SSEL'S NAME Steel S.S. "ATLANTIC". Rpt. Mmo. No. 248.

The remarks of the Chief Ship Surveyor are desired on this case for the consideration of the Classing Committee.

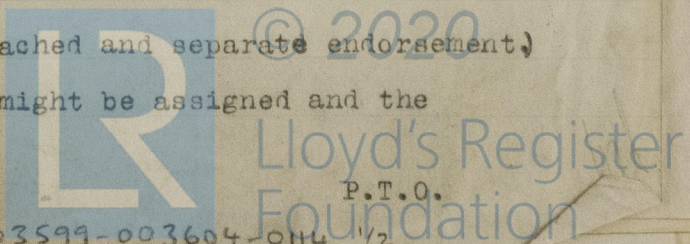
The anchors have been tested by the Bureau Veritas Surveyors at Dortmund, and the chain cables at Cradley Heath.

Cwt. Qrs. lbs.				Cwt. Qrs. lbs.				Cwt. Qrs. lbs.	
		18 1 11, and the stock									
Cwt.	Qrs.	lbs.	Cwt.	Qrs.	lbs.	Cwt.	Qrs.	lbs.	Cwt.	Qrs.	lbs.
3	1	26,	instead of	17	2	0	and	4	1	14,	respectively

The weight including stock is equal to Rule, and it is submitted the anchor stock which in this case is 19% of the actual weight of the anchors instead of 25% as required, might be approved, and the Surveyors' attention should be called to the Rules with regard to the weights of anchor stocks.
